ADDENDUM NUMBER ONE (1)

**Lake County Dog Shelter
Boiler and Fluid Cooler**
2600 N. Ridge Road
Painesville, OH 44077

Lake County Board of Commissioners

Scheeser Buckley Mayfield
1540 Corporate Woods Parkway
Uniontown, Ohio 44685

SKE1-0

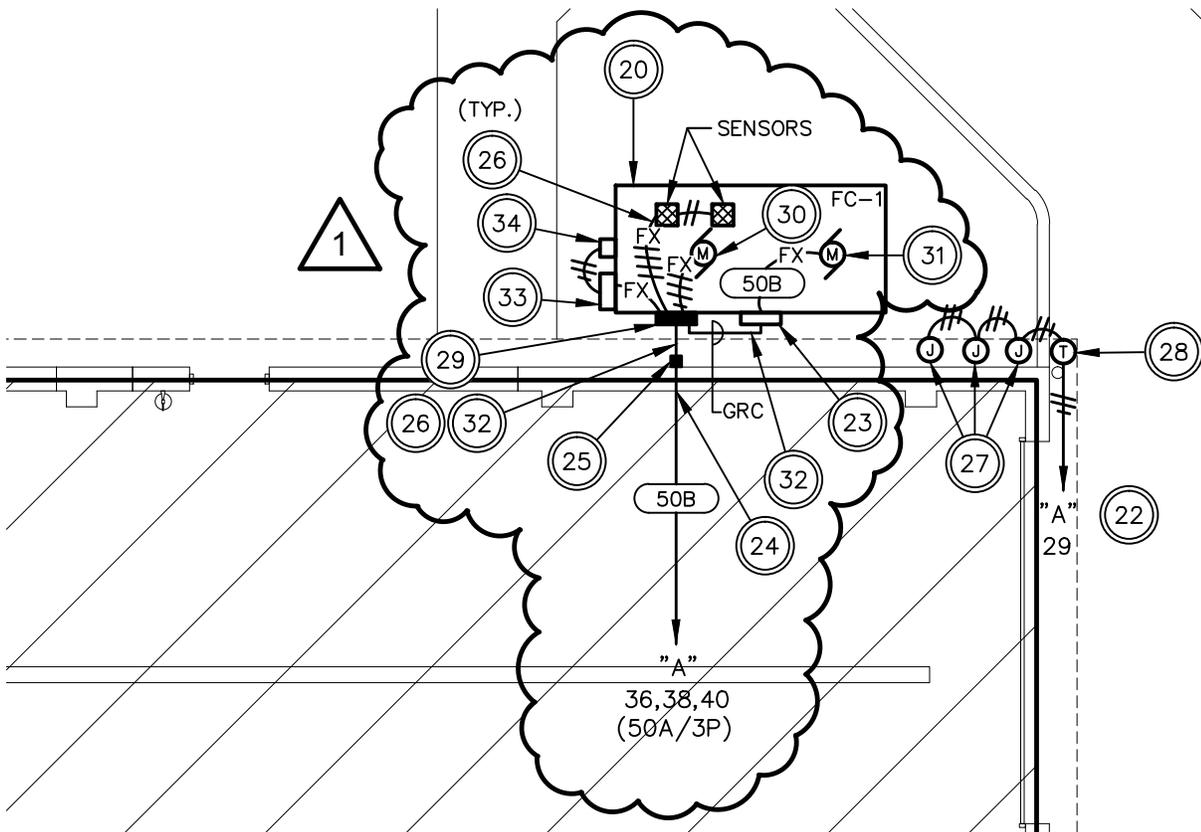
ITEM NO. 1: Drawing E1-0 – NEW WORK – GROUND FLOOR PLAN – ELECTRICAL

1. Refer to sketch drawing SKE1-0 for revised Fluid Cooler electrical design. Coordinate wiring with fluid cooler manufacturer.

23. VARIABLE FREQUENCY DRIVE WITH NEMA 3R ENCLOSURE FURNISHED BY MC, EC TO INSTALL AND POWER WIRE.

29. STARTER PANEL (208V,3 ϕ) WITH NEMA 3R ENCLOSURE FOR EVAPORATOR FLUID COOLER "FC-1".

30. WATER PUMP (0.5HP,208V,3 ϕ).

31. FLUID COOLER MOTOR (7.5HP,208V,3 ϕ).
